SUBDIVISION Carriage Mills

ROAD 14716 Carriage Mill Drive

RE: Variance Request – proposed addition less than 20' from Septic Tank

Re: Variance Request- proposed addition less than 20 feet from septic tank

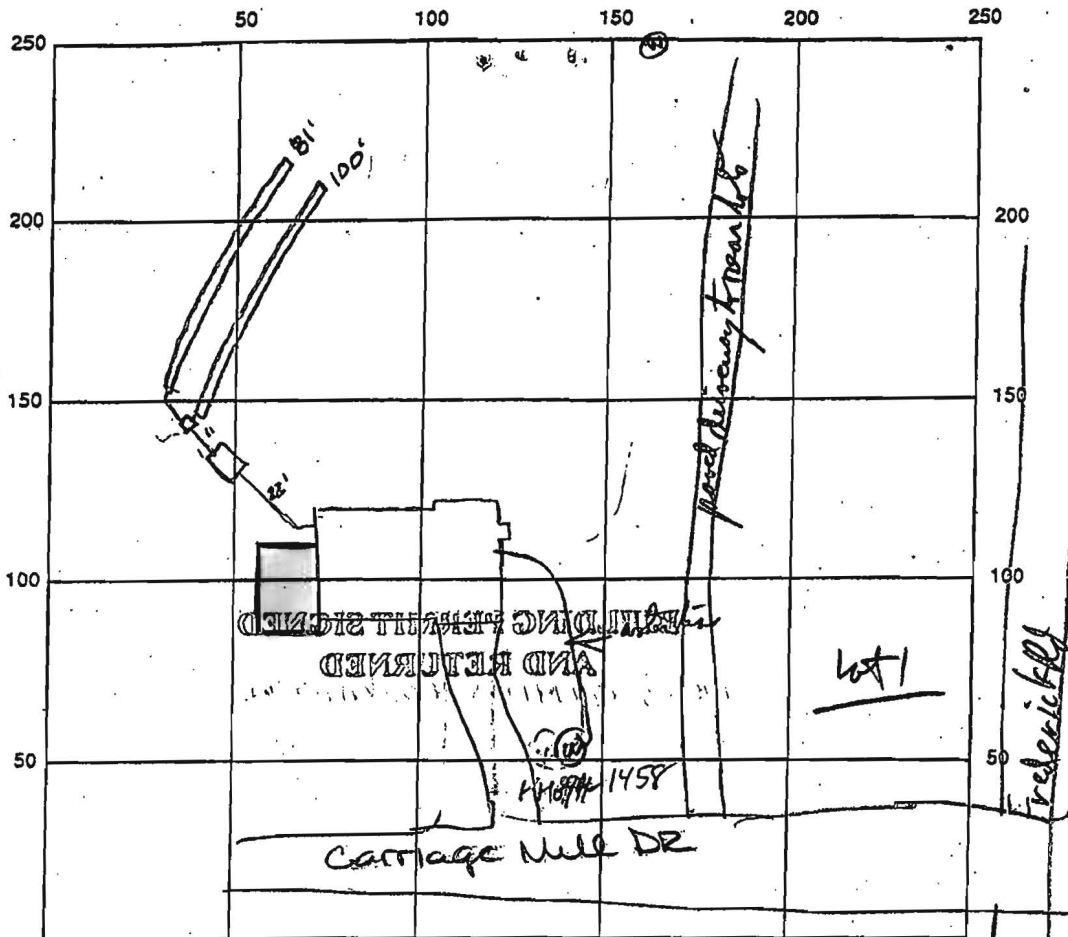
The attached house diagram and site map show the location of the addition to the septic tank. I have also enclosed a photograph of the area to show the elevation has a downhill slope away from the addition to the septic tank, as you can see from the grading against the house. The septic cap is also visible in the photograph.

Need proposed
floor elev vs compared
to ground elevation @ Septic Tank

Your request for the referenced variance has been considered by this department and has been determined to be inconclusive at this time. The reason for this is the lack of two elevations key to this consideration. In order for a conclusive decision on this request, please provide this office with the proposed floor elevation of the basement addition and the elevation of the current grade at the septic tank.

These elevations need not be precise elevations with comparison to sea level; but rather a simple measurement of the two heights, such as +2 inches and -5 inches or similar measurements that can be obtained with a transit or eye level. If the basement in the addition is to be the same elevation as the existing basement in the house then the measurement may be provided from there.

I would like to take this opportunity to inform you that the existing septic tank installed on your property is a 1,250 gallon tank. Howard County Code section 3.8 requires that houses between 1,501 and 3,500 square feet have a 1,500 gallon septic tank. Government tax records indicate that your house is currently 2,610 square feet and your proposed addition will push that number to 2,970 square feet. No building permits will be issued for your property without upgrading your septic tank to a 1,500 gallon minimum capacity.
